PCN/21/026/C+N-US

Product range: Han

Title: Han 3 HPR O-ring change

Old contour o-ring seal	New round o-ring seal

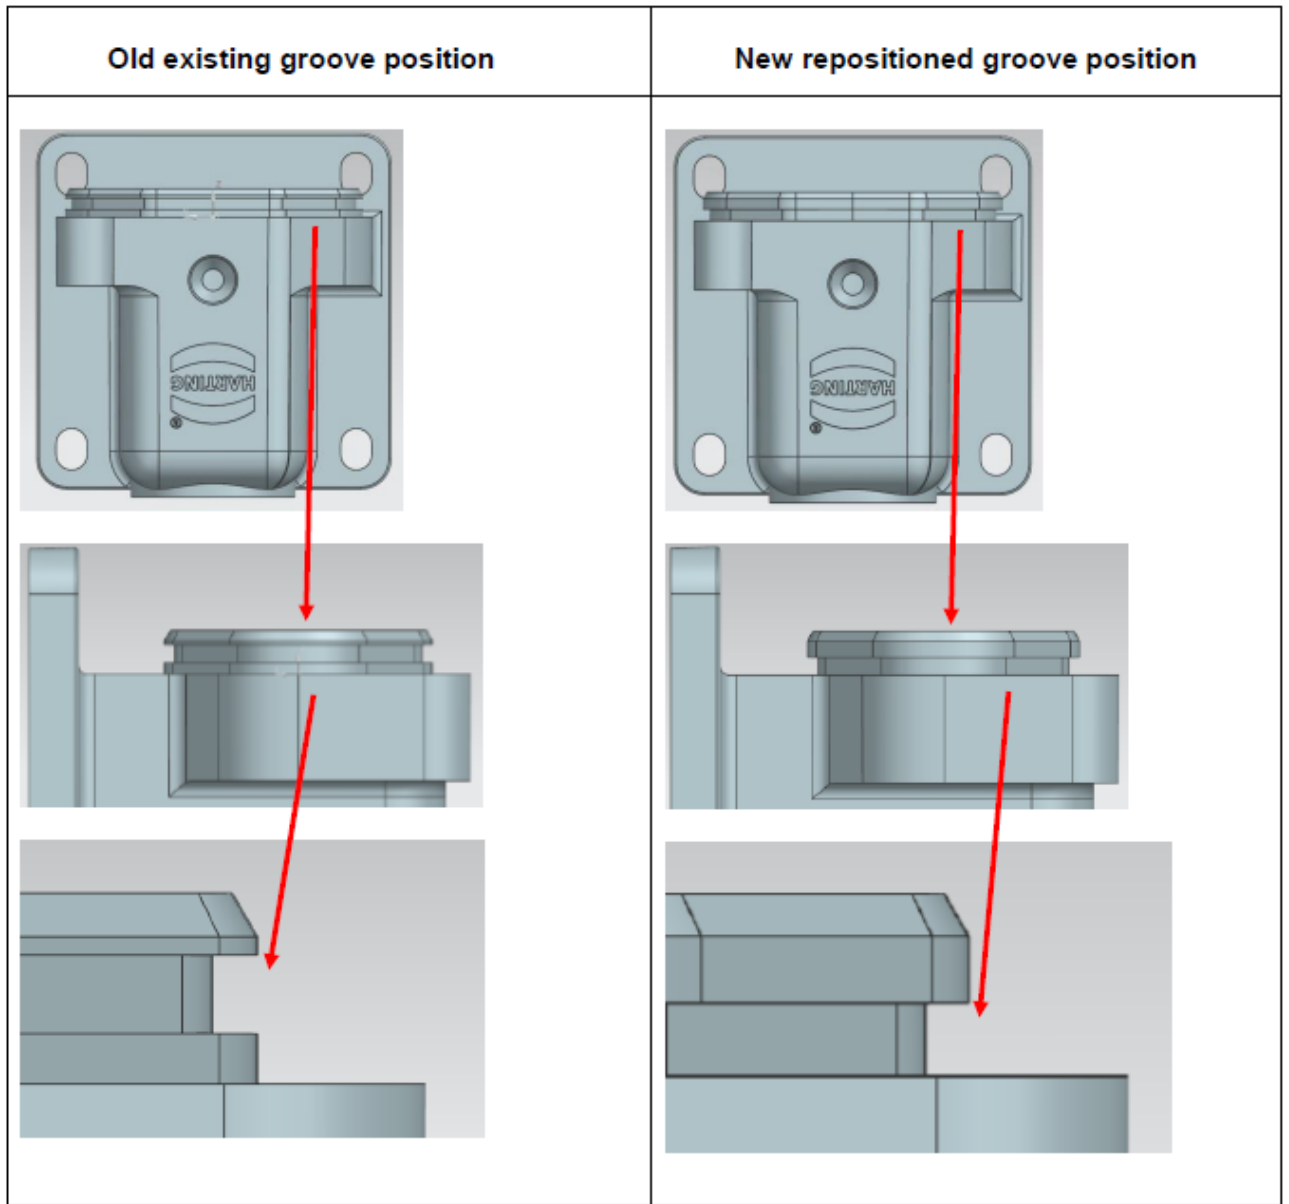
For the Han® 3 HPR housings and covers for the hoods, the existing contour of the o-ring seal in the mating area will be changed to a round o-ring. In addition, the groove for the seal in the mold will be repositioned.

The packaging content of the accessory part number 09400009910 will be equipped in the future with the existing contour o-ring as well as the new round o-ring seal.

There are no effects on the technical characteristics by this change
